**718 Yesler Way**  
**RECOMMENDATION PACKET**

Project # 3038868-LU

Design Recommendation - Project # 3038868-LU

Meeting notes from DRB turn page session with planner 12/20/23

Proposed project as seen from I-5.

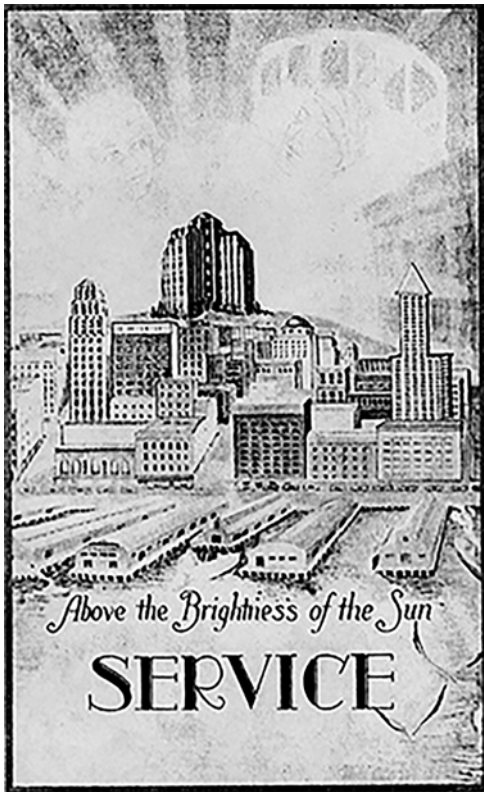
i. The Board acknowledged the challenge of creating a gateway moment with limited height, but would like to see the lantern element further strengthened. (CS2-A Location in the City and Neighborhood)

*Although reduced in scope, primarily in height, the project continues the design strategies of the Pacific Tower and Harbor View Hospital, using strong verticals and stepped massing of the Art Deco movement, to give a commanding and distinctive architecture as expected for a landmark building. The lantern element, which was an illuminated elevator penthouse, is no longer possible with the change in program and building type. We are not able to extend or design any rooftop features as we are at the height limit for a podium building.*

View of proposed hotel as coming up Yesler from Downtown

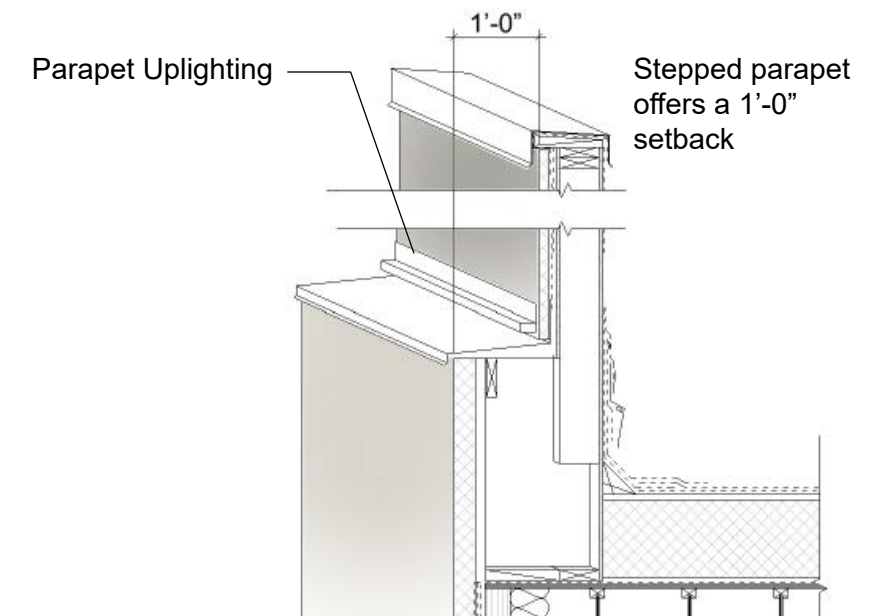
iii. The Board directed further refinement of the west elevation by incorporating more articulation and carrying the language of the Yesler Way and access drive facing-façades to the west elevation. (DC2-B-1 Façade Composition)

*The design of Art Deco architecture was symmetrical along a central axis with each façade the same or similar. Following in the same rigor, the architecture language of the West façade is the same as the South and Eastern facades. The West façade bay projects forward and the same stepped parapet treatment is given.*

The bay on the West facade is projected 1' -0" and its parapet is stepped to emphasize it height as well as an increased contrast in color given to the bays.

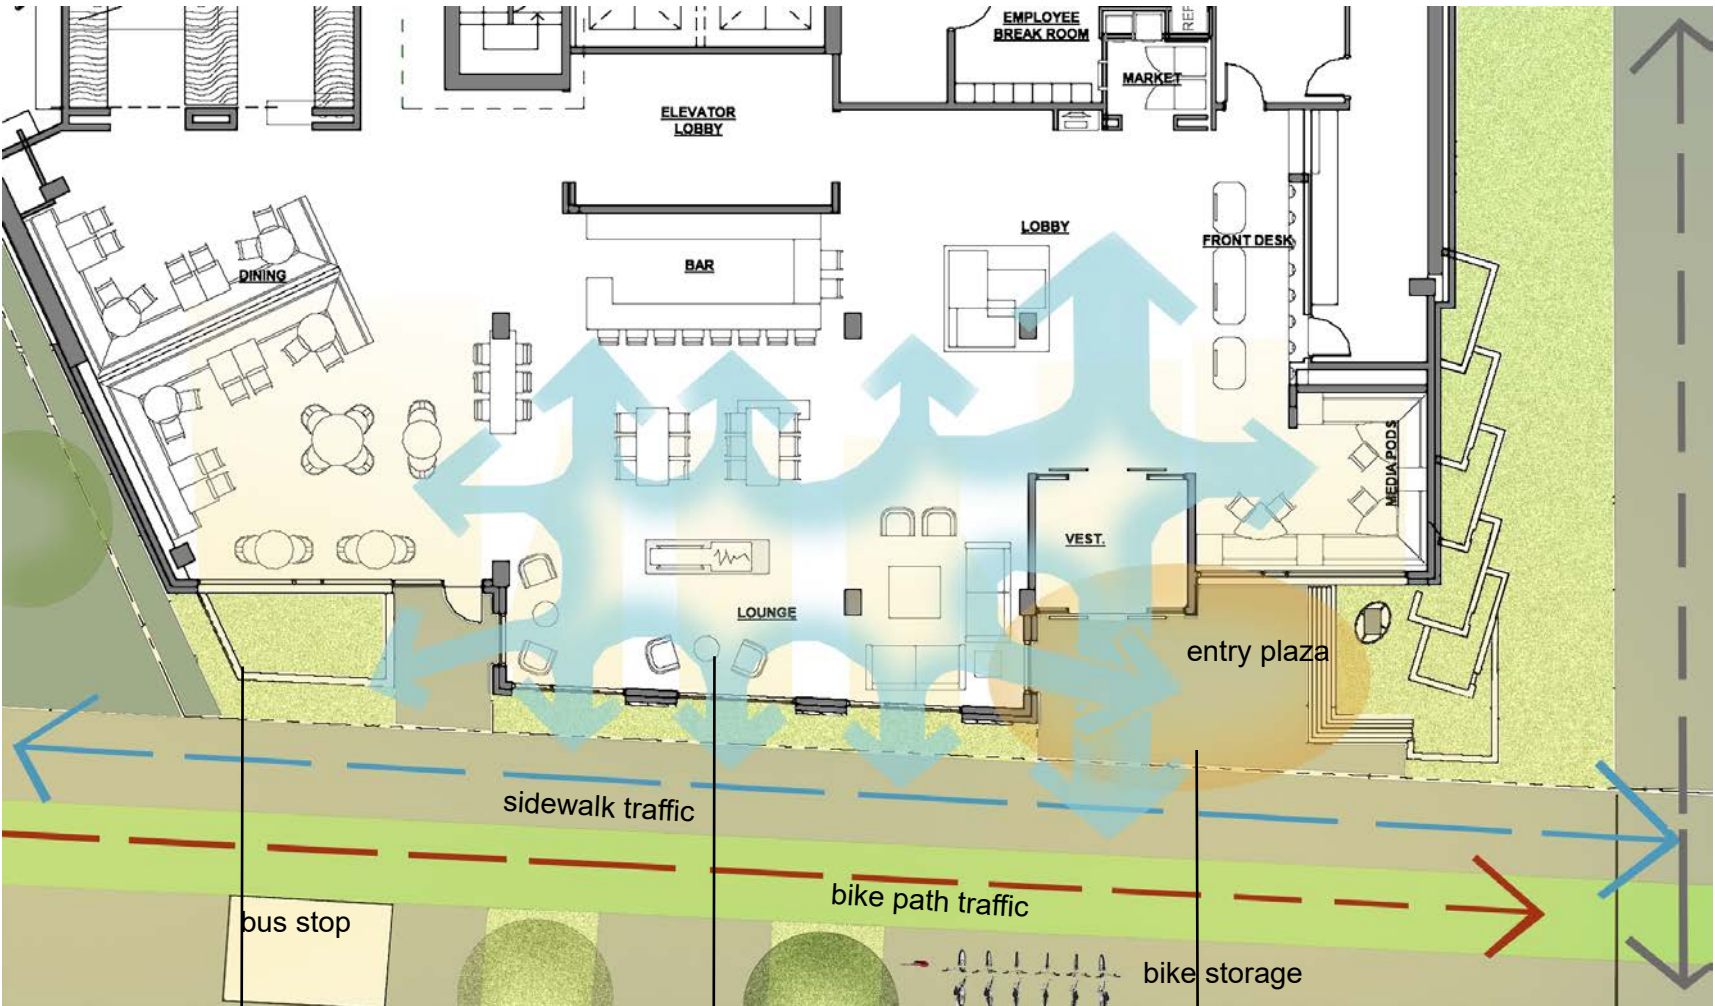
e. The Board requested information on how stormwater design will be integrated into the landscape plan. (CS1-E Water – Yesler Terrace)

*A stepped stormwater planter will be featured along the access drive that flows into the entry plaza planting. The intersection of the access drive and Yesler is the only actual intersection of the project and the stormwater feature was placed here for the best sidewalk and entry plaza interaction.*

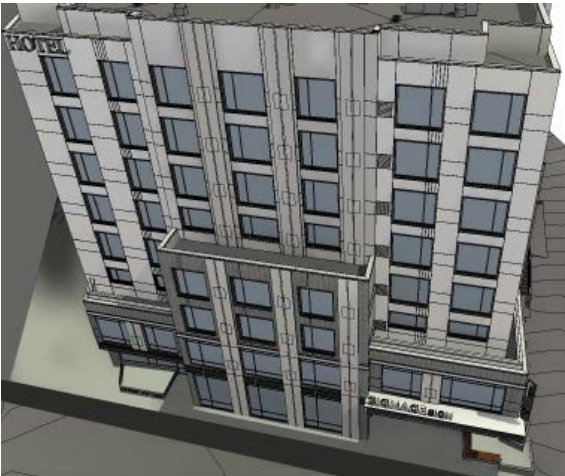
d. The Board requested to see day and night images of the lighting design in the Recommendation packet, particularly of the lantern element. (DC2-B Architectural and Facade Composition, CS2-C-1 Corner Sites, DC4-C Lighting)

Night renderings of the project provided.

Lit welcome signage will be created from LED strip light set into metal letters. The LED lighting can be programmed to be artistically themed and changed as desired.

LED lighting will highlight the building's horizontals

Architectural up-lighting will emphasize the buildings verticals

Above the podium / Refinements above the brick  
*Response to line item 7.*

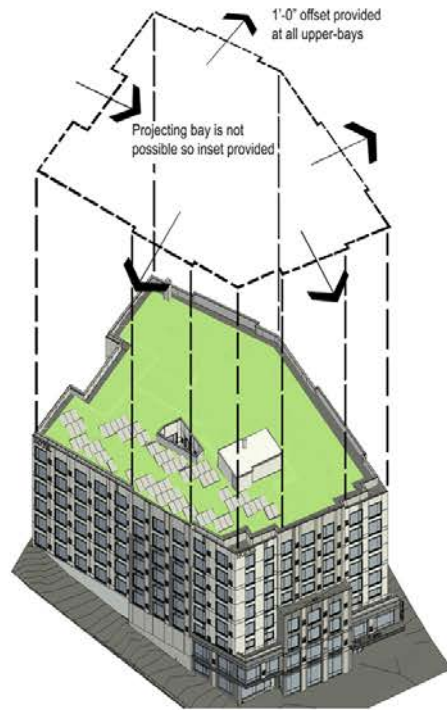
7. Portion of the building above the brick – need to further develop detailing and make design moves intentional. *See response this page.*
  8. Include detail information/more clarity in final packet for the following areas:

Since the original EDG precedents studies, an art deco inspired massing of projecting bays, set in a A,B,C, pattern for each façade has led the design development of the project. Recent enhancements to the Art Deco sculpting, has reduced the building’s upper story footprint on each side of the projecting bay to allow a minimum 1’-0” projection for each façade. In some locations this has doubled the change in plane from projecting bays to building proper. At the top of the building, the secondary top parapets have been recessed back further which will further enhance the sculpted top.

At the buildings “ribs”, secondary elements have been revised to enhance the verticals by flanking the VTAC louvers with reveals versus centering them doubling the verticals.. Additionally, the amount of overall horizontal reveals has been reduced to the building proper, while at the same time additional vertical reveals have been added, centered at each of the VTAC locations. Finally, the contrast of façade colors has been increased slightly, darkening the building bays, just enough to not stray from the minimal palette as directed from EDG. The combined effect of these refinements finds a building with stronger verticality, and a better understood Art Deco inspired modern building.
